Product Change Notice (PCN)

PCN Number: PCN-0455011R-01

Product(s) Affected: **SJ-3523-SMT-TR & SJ-3524-SMT-TR**

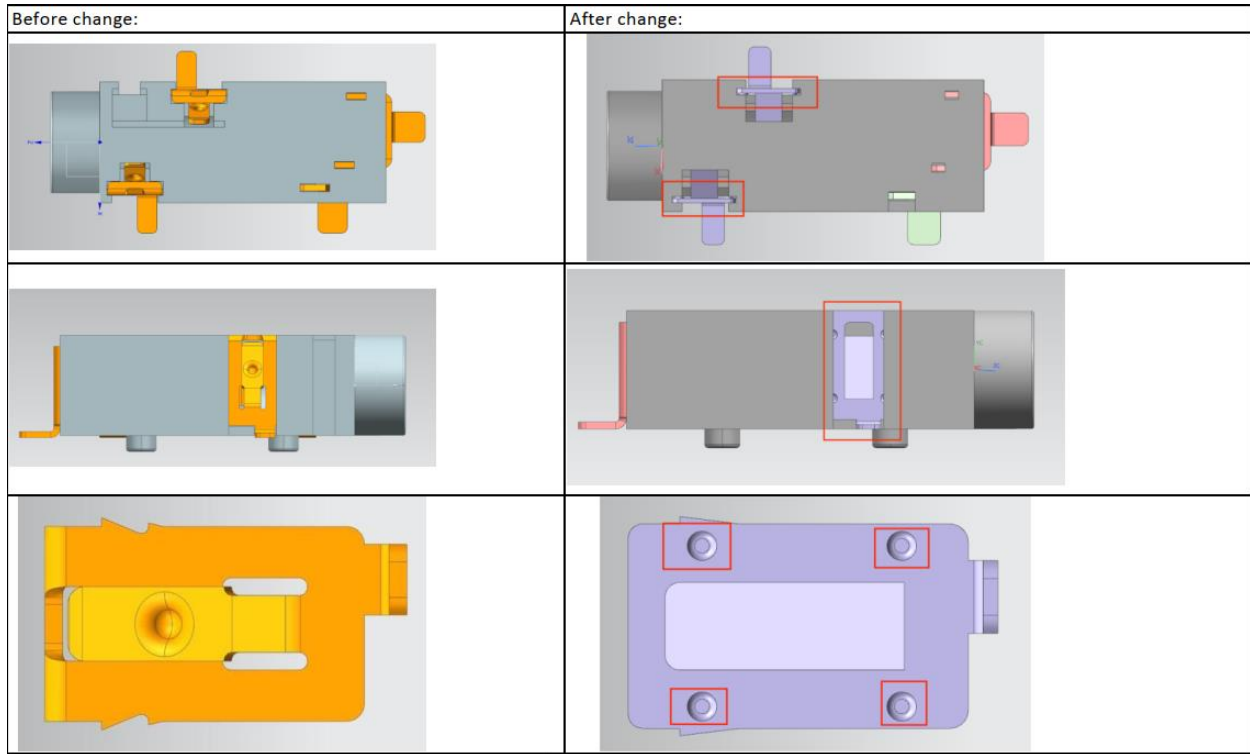
- 1) Removal of additional slots in the base. Plastic structural change.
- 2) Hardware/Shielding adjustment.
- 3) Terminal 4 material change to Brass.

No Change to PCB Footprint

See image below for reference and check Same Sky website for updated drawing. Cosmetic differences may be visible due to new molds and not affect the form fit and function of the product.
